INLAND FISHERIES AND WILDLIFE NATURE PARK - ADDENDUM #1

date: May 13, 2024
project: Inland Fisheries and Wildlife Store and Admin Office Project # 3096
prepared by: Ryan Kanteres Simons Architects
Adam Wiles-Rosell Simons Architects
Mikayla Molta Simons Architects

Subject: **Addendum #1** to Bid Documents of April 23, 2024

A313

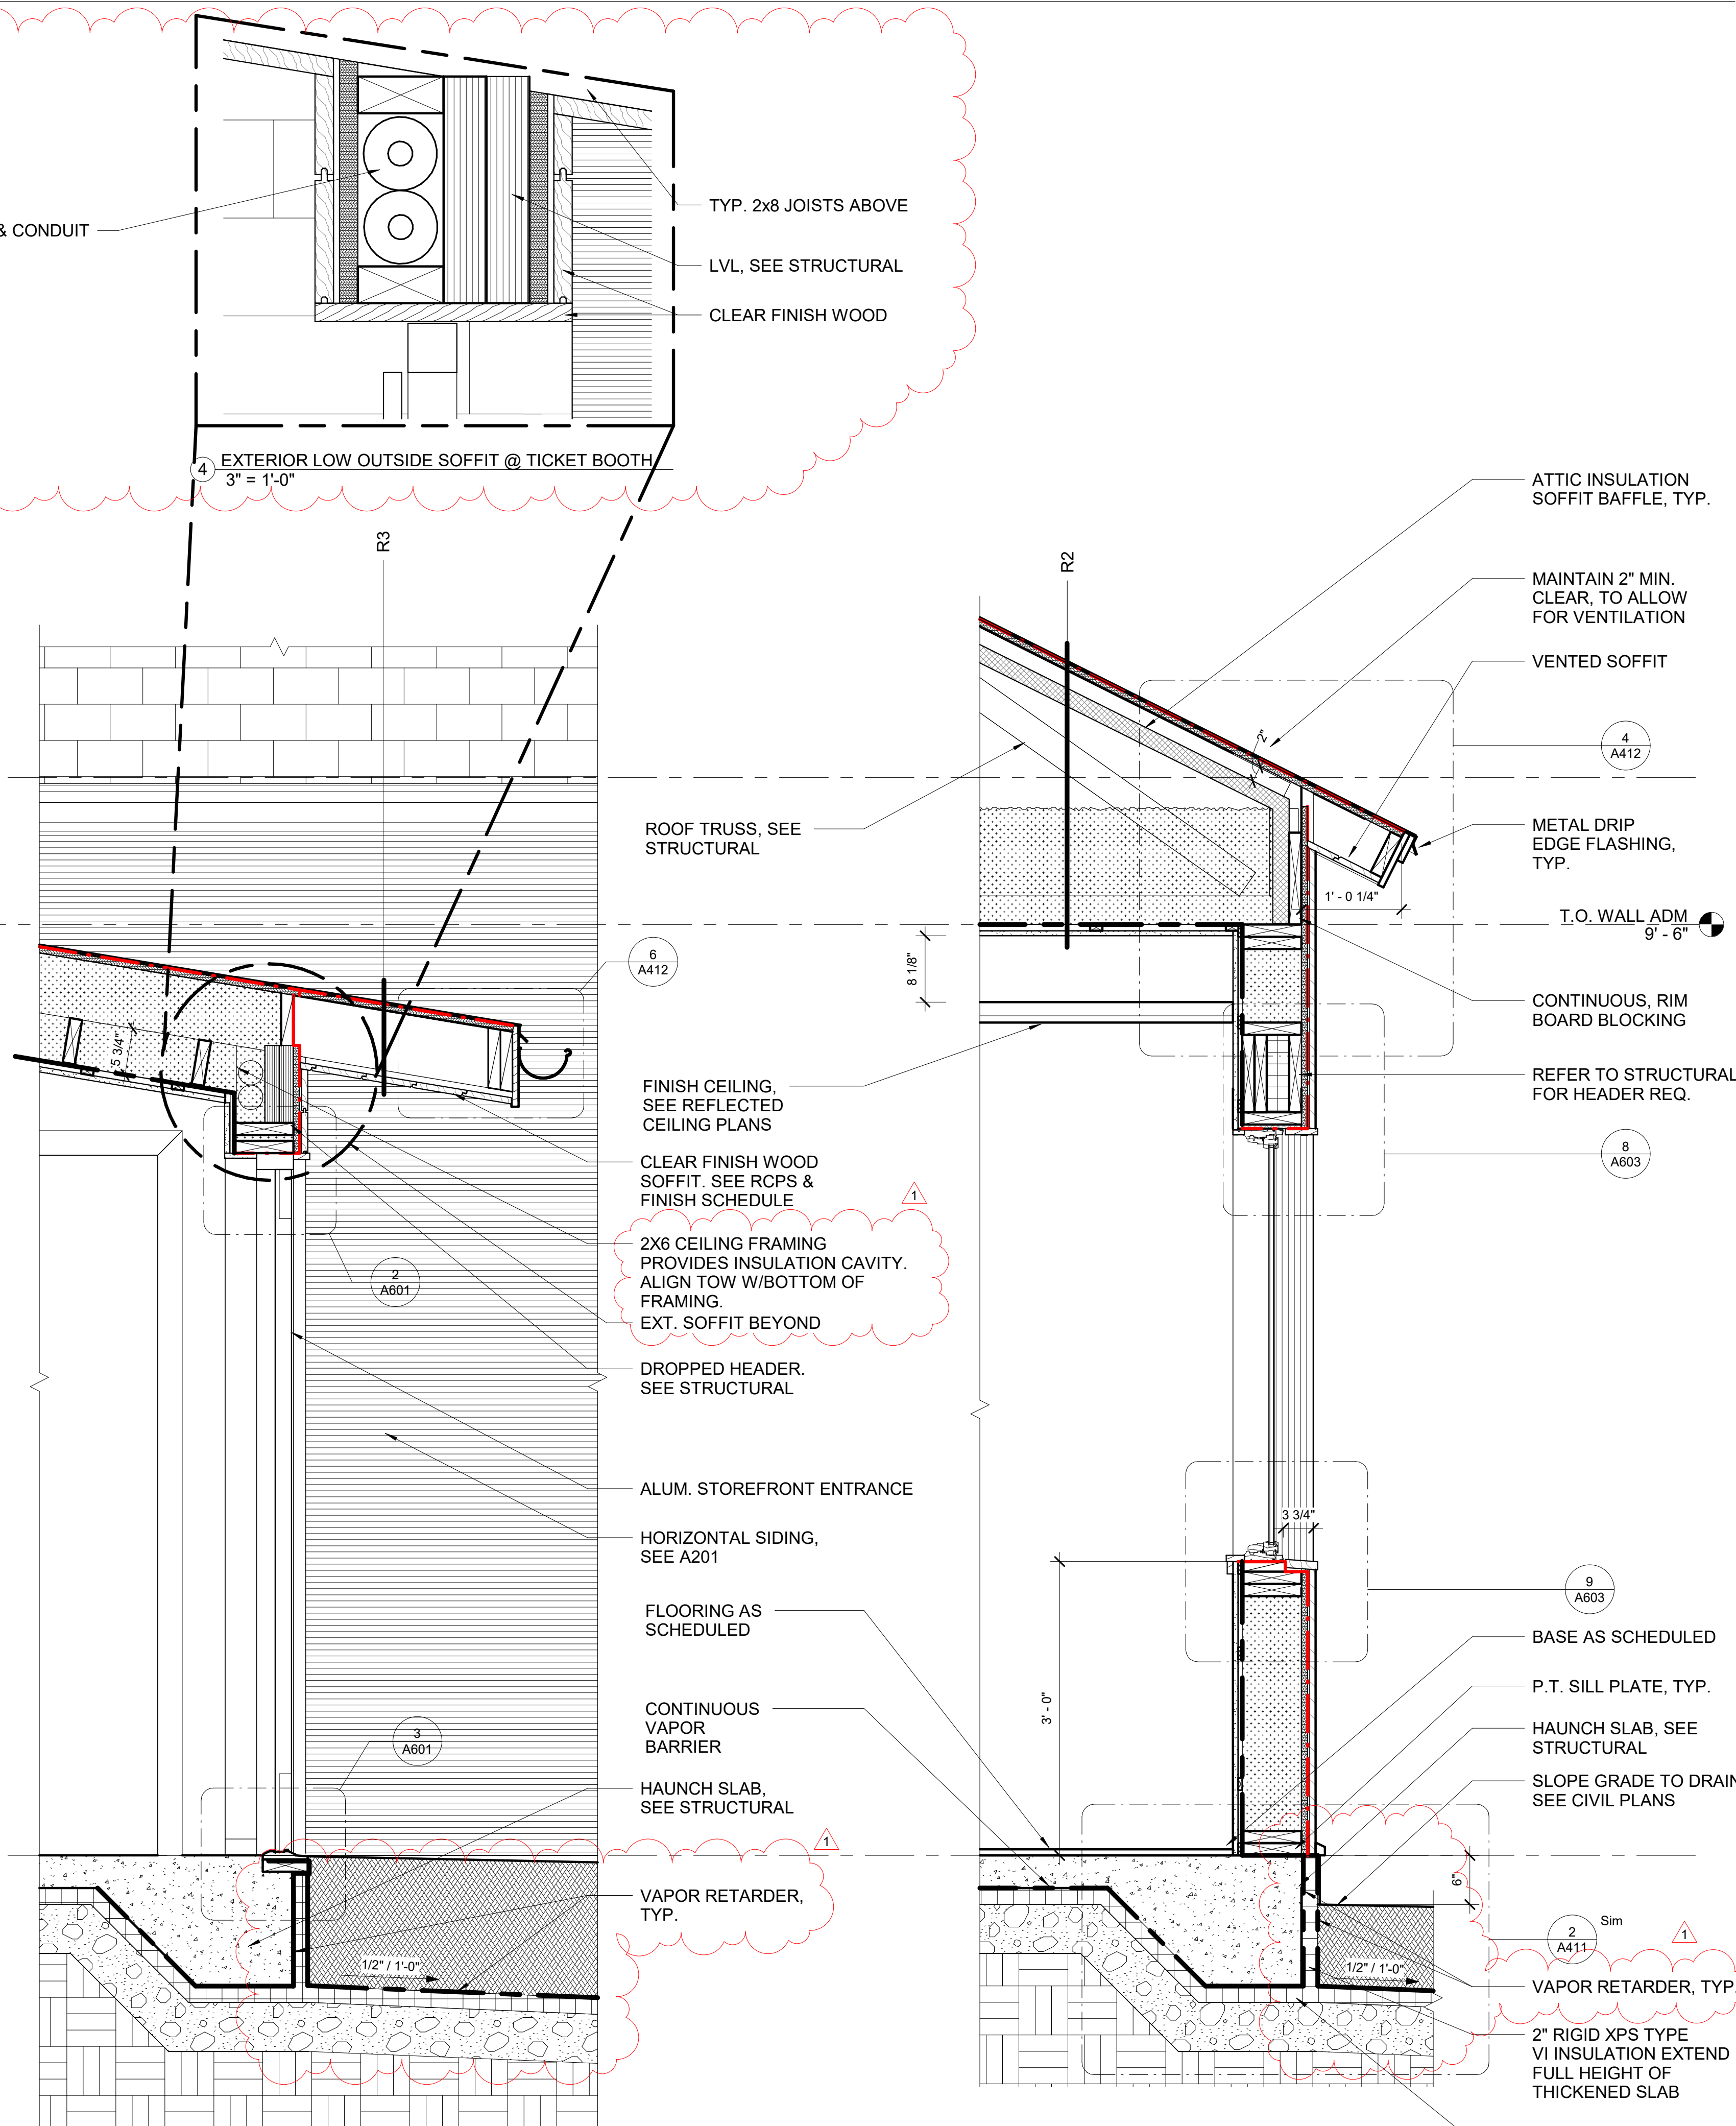
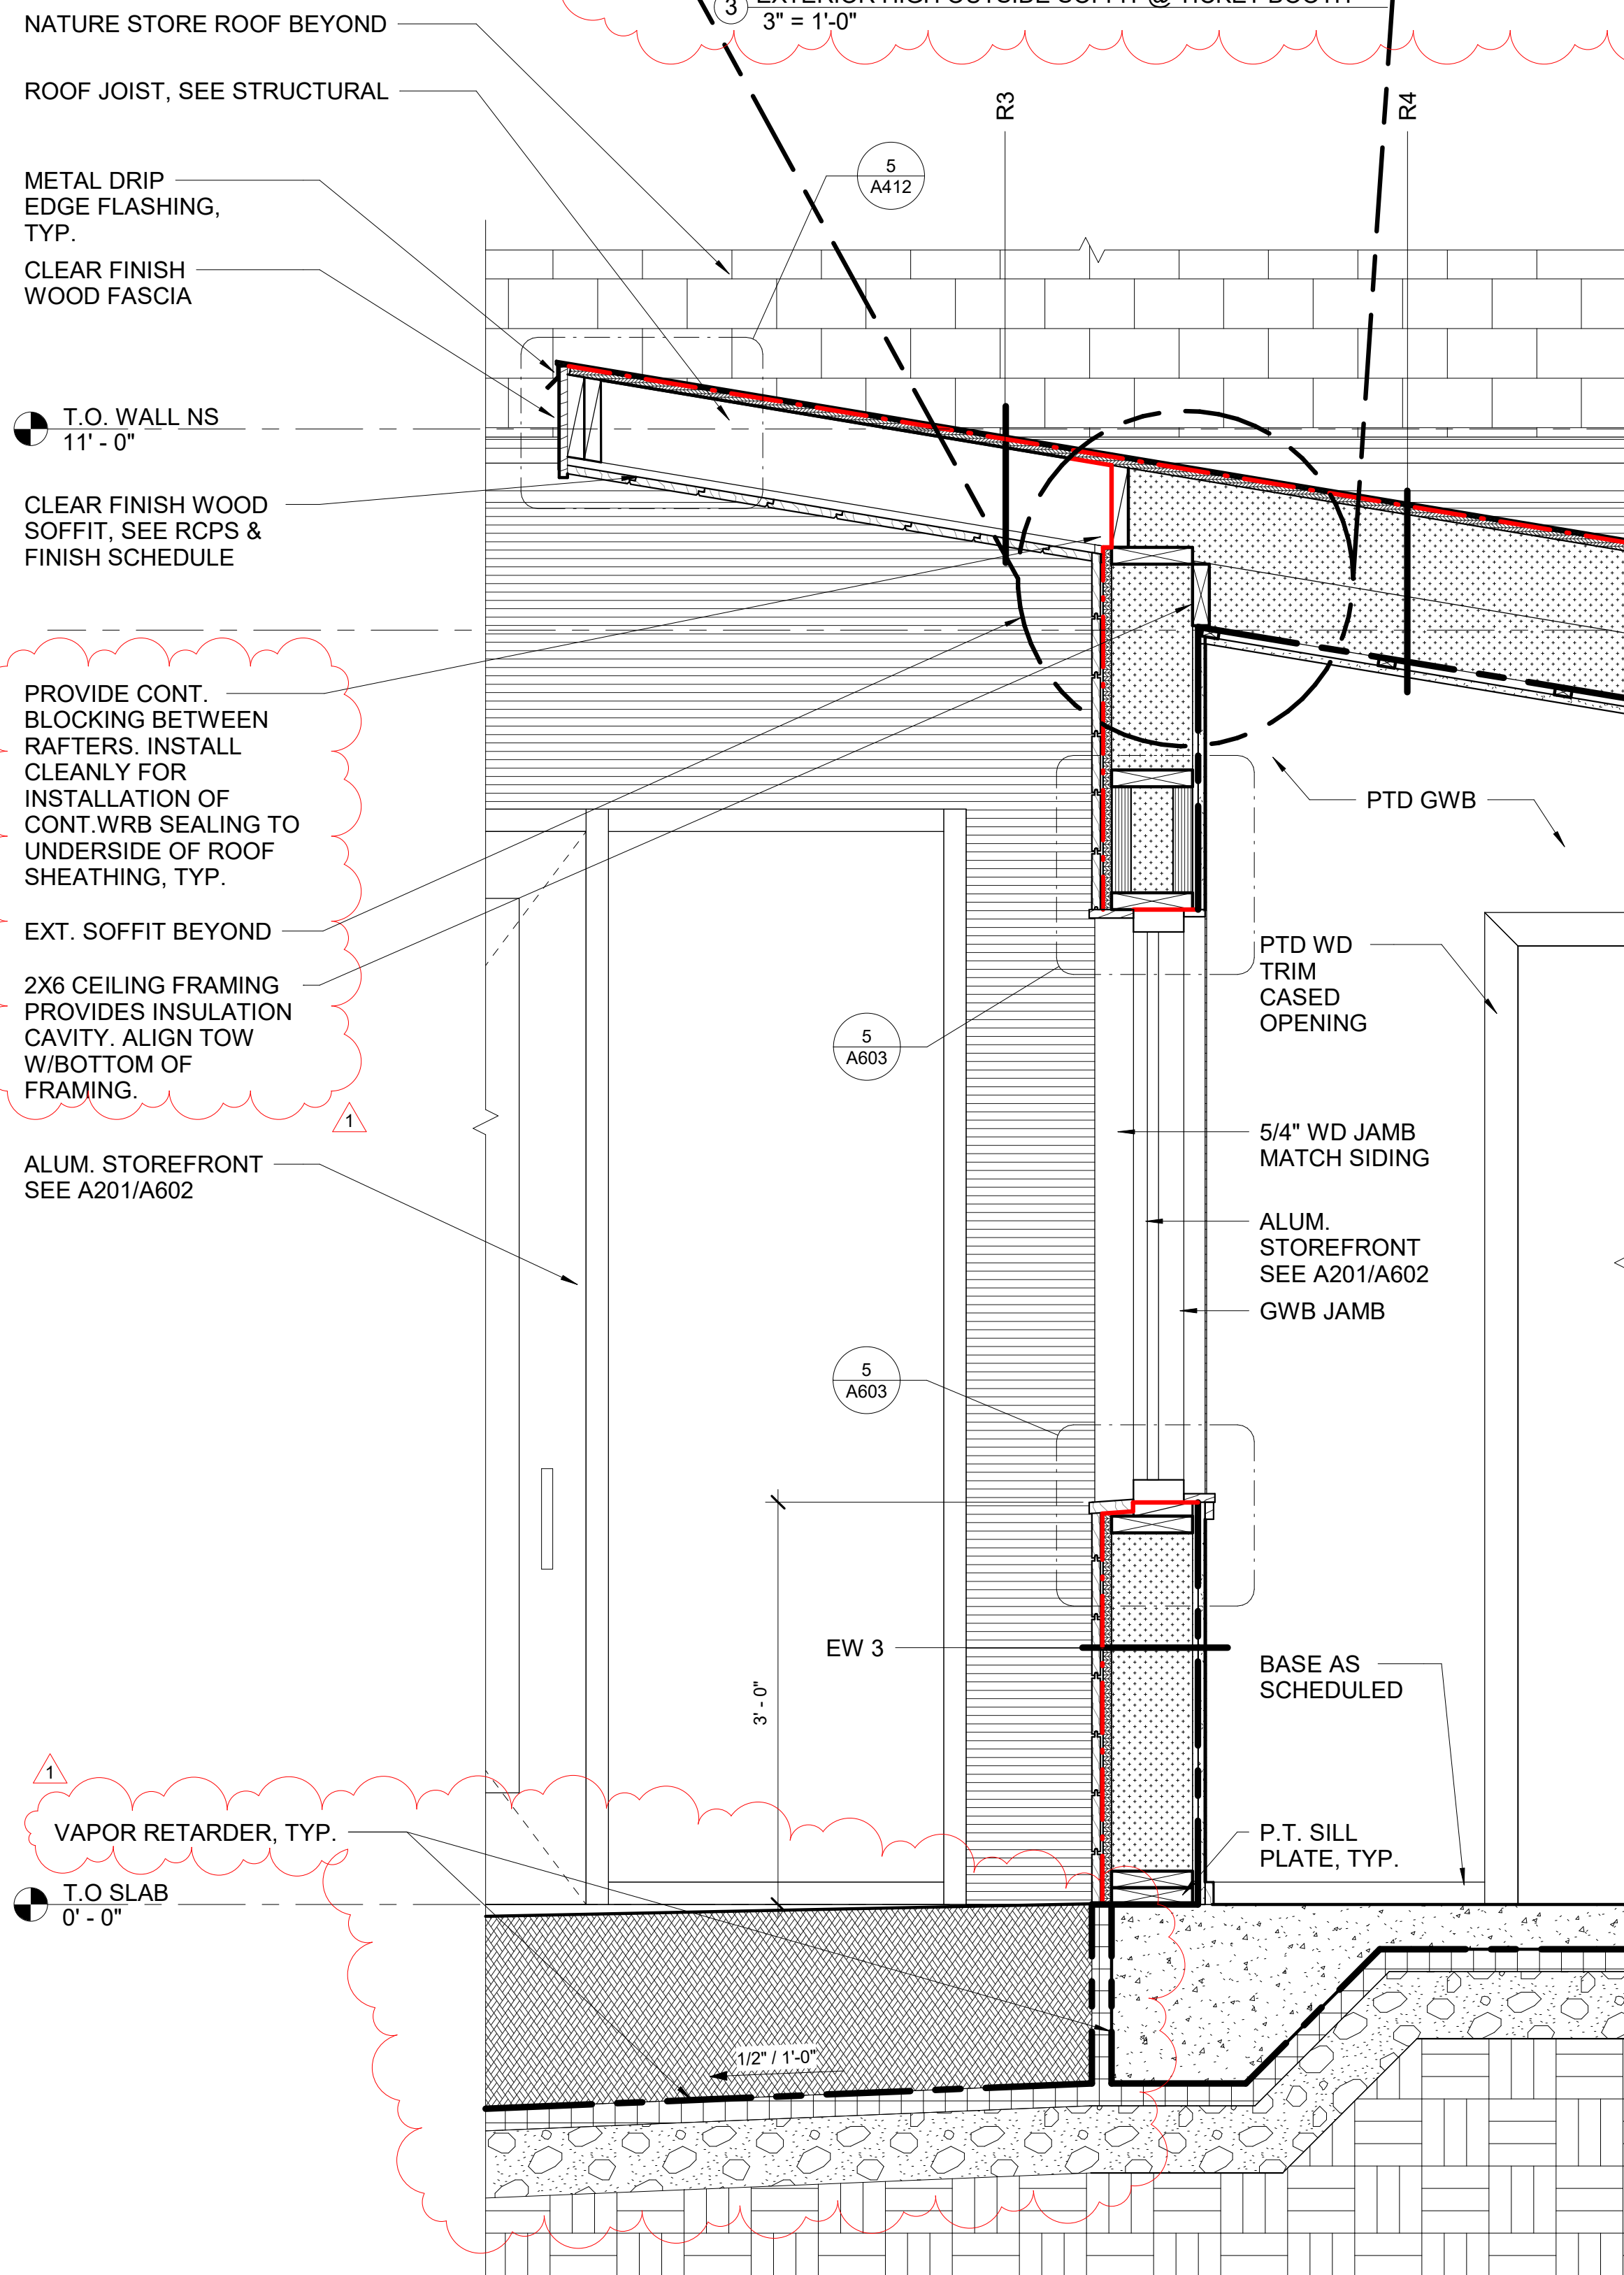
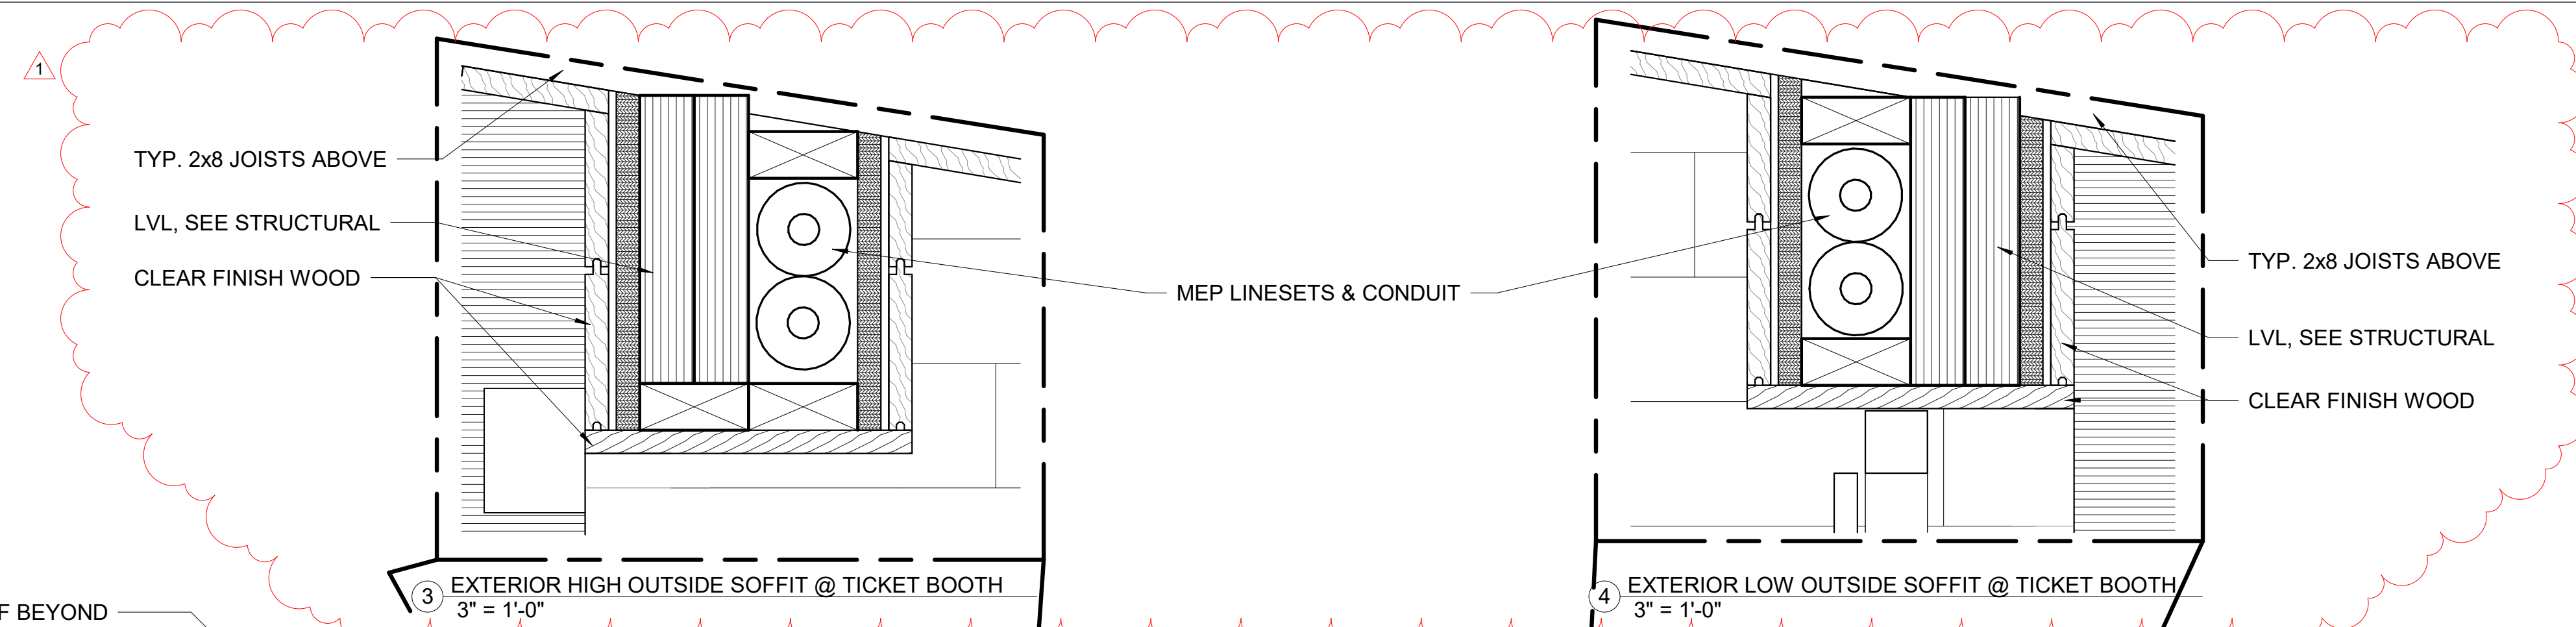
- 1-D16 Sheet A313 Adjusted WRB sealing termination to underside of sheathing in place of lapping over top of wall and sealing to interior AVB. Provide solid blocking between rafters. Coordinated sloped horizontal rigid insulation and vapor retarder with structural foundation plan and sections. 2x6 ceiling framing provided for continuous insulation cavity. MEP line sets and conduit coordinated with additional detail information.
